TECHNICAL NEWS

[Issue No.] LVS-YE-0006

[Title] Correction of the external dimensions for F Type Operating Handles.

[Relevant Models] F Type Operating Handle (Type name:F-03SV)

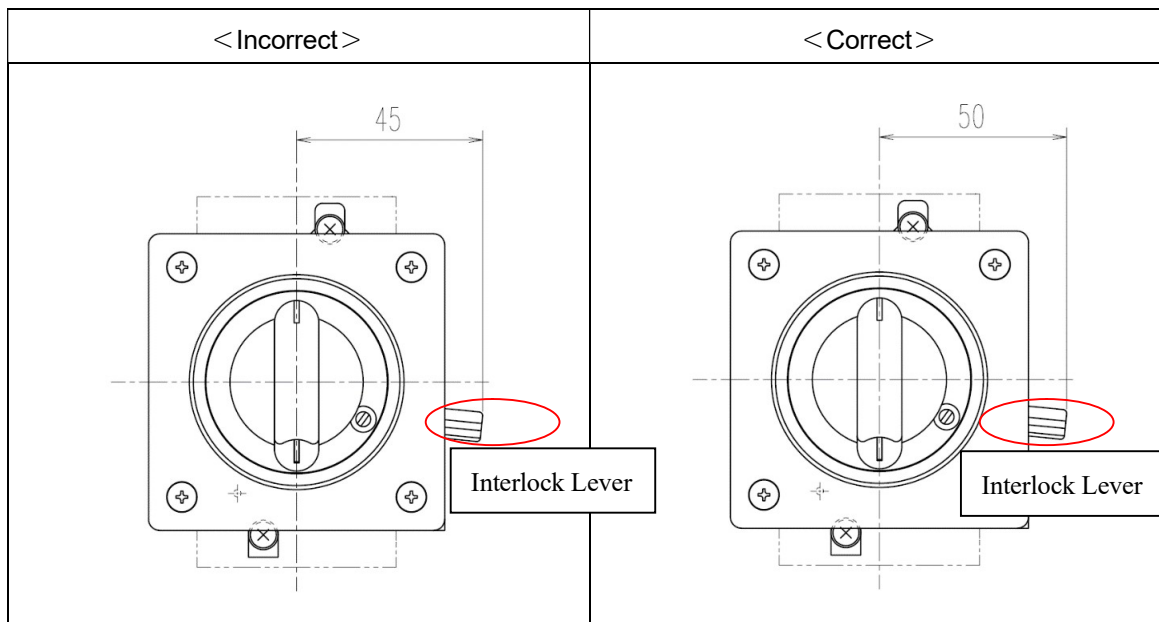
Changed the dimension from the central part of the handle to the tip of the interlock lever (Red Circle) from 45 to 50 mm.
